MEMORANDUM

RE: ZP 13-0768CA; 107 Ledge Road

Request: Amend previously approved permit (approved April 15, 2013) including smaller massing of addition and garage, window changes.

A2.1

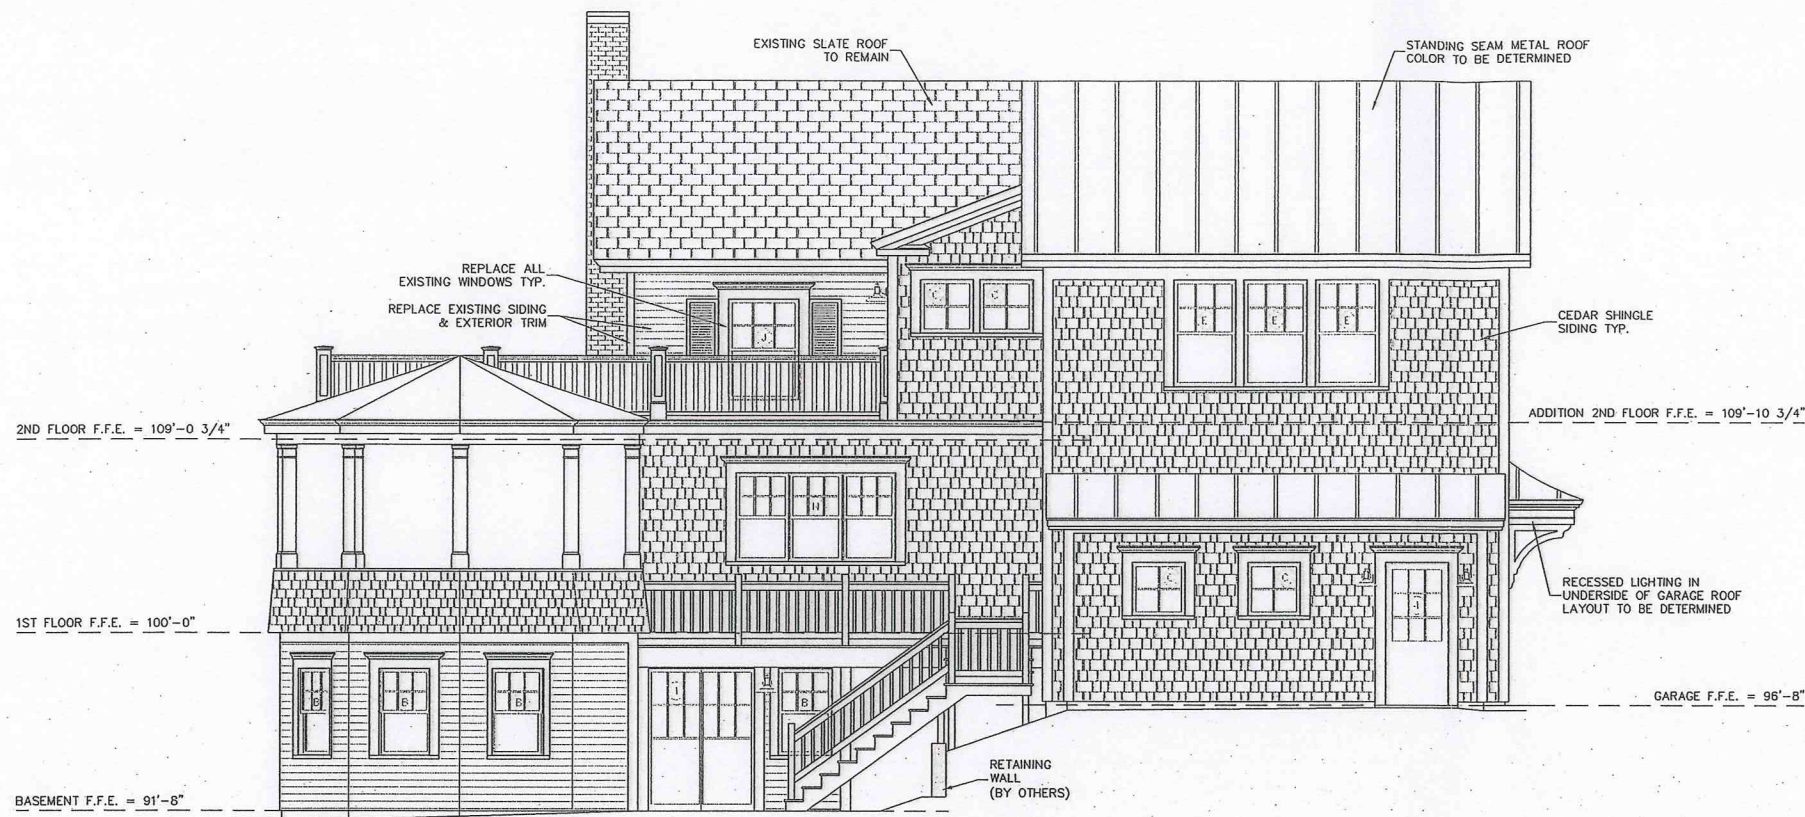
DRB approval included condition #14: *The windows on the sunroom shall be increased to fill the wall section going corner to corner (similar to the original sunroom) on the north (front) and west elevations, as they are the most visible.* In placing this condition, the DRB recognized the significant character provided by the original sunroom window arrangement, and inserted a provision to retain that particular feature of the structure. The applicant now wishes to have that condition re-considered, with insertion of modern double hung windows on the north (front), and smaller square windows on the west. This suggestion negates the importance of the sunroom feature and ignores the sunroom addition as being a significant and architecturally compatible addition to the Colonial Revival home. The original condition, requiring installation of full-wall fenestration on the north and the west, will retain that historic feature, and is recommended for retention. **Adverse finding** for revised windows arrangement. **Affirmative finding** if Condition #14 upheld.

Adverse finding for proposed sunroom windows. **Affirmative finding** if Condition #14 upheld.

The original sunroom windows, however, are identified as being a character defining feature of this early 20th century home. The DAB and staff concur that these large window openings should be retained, at least on observable elevations. Condition #14, with windows that go from corner to corner, is recommended for retention. **Adverse finding** for revised sunroom windows. **Affirmative finding if Condition #14 upheld.**

- PROPOSED ROOF DECK W/ RAIL SYSTEM**: Points to the roof deck area.
- 36" HIGH**: Vertical dimension for the roof deck railing.
- Handwritten note**: "See condition #14" with a large 'X' over the right side of the drawing.

Recommendation: **Approval** of the reduced massing, roofline changes and associated siding, porch and entry alterations. **Denial of the request to alter Condition #14**; per the following findings and conditions:

previously approved site plan

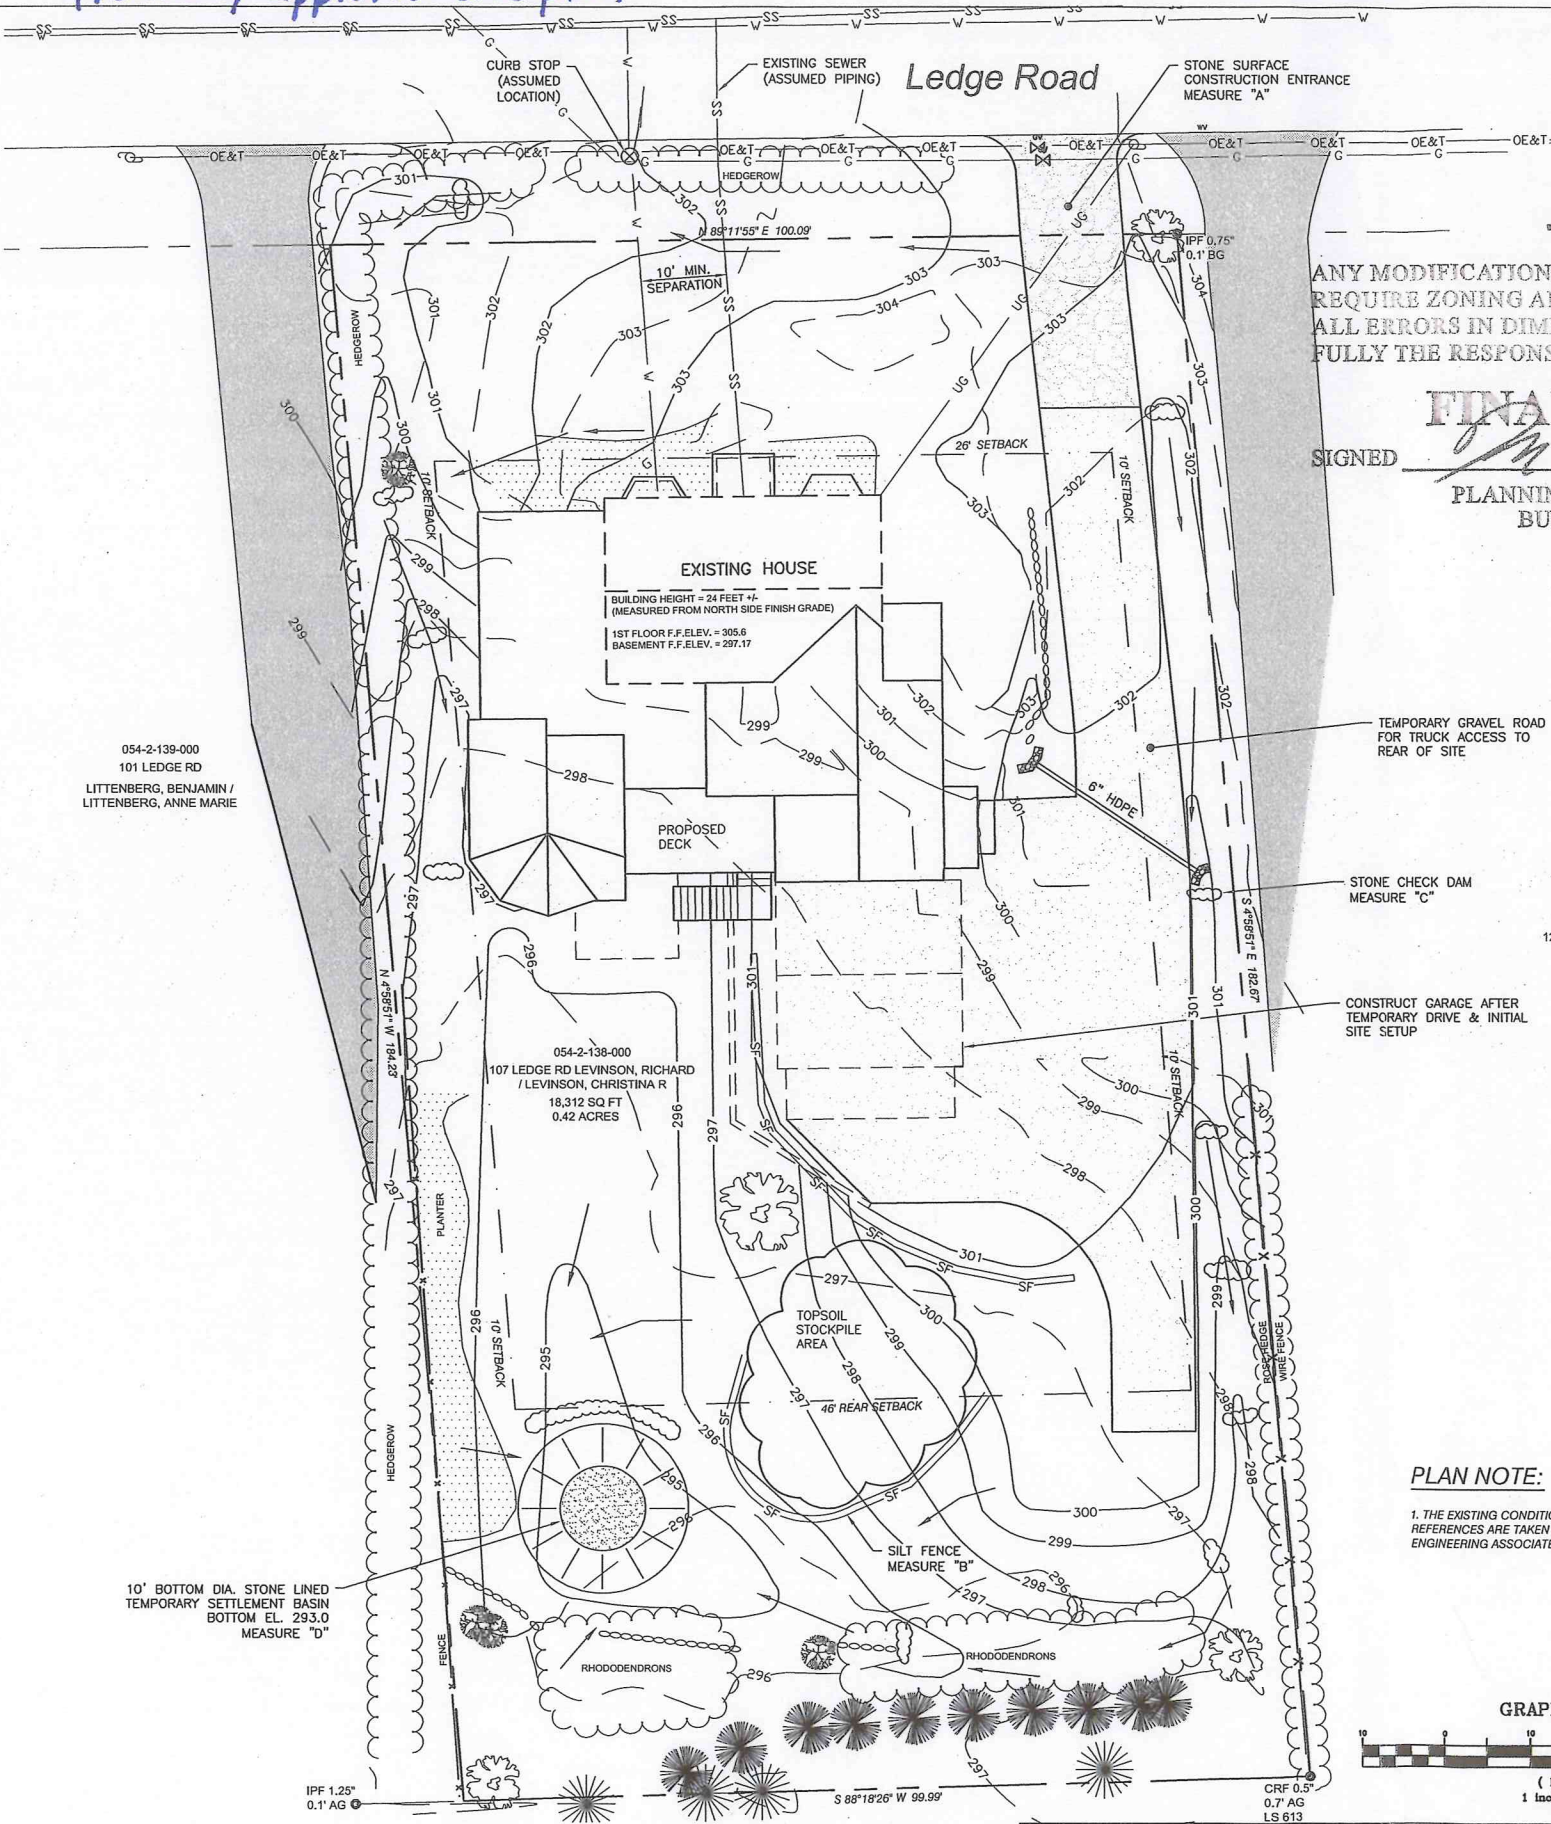
Although the revised plans detail re-arrangement of windows and doors in the new addition, no concern is raised. The newly recessed side entryway appears to change the building footprint, which will require a revision to the previously approved site plan and coverage calculation.

1. It has been assumed that no footprint changes occur with these alterations. If the building footprint changes and/or there is a change of coverage, a revised site plan and coverage calculation will be required **prior to release of the zoning permit.**
2. Condition #14 of the original approval shall be upheld: The large windows of the enclosed sun room shall be retained or replicated as an existing feature of the building, at the very least on the primary façade and westerly elevation (most visible.)
3. The location of meters, mailboxes, and any other utilities or HVAC equipment will need to be illustrated on elevations and/or site plans, as appropriate, **prior to release of the zoning permit.**
4. All conditions previously included as part of ZP 13-0768CA shall remain in effect, unless herein altered.
5. Standard Permit Conditions 1-15.
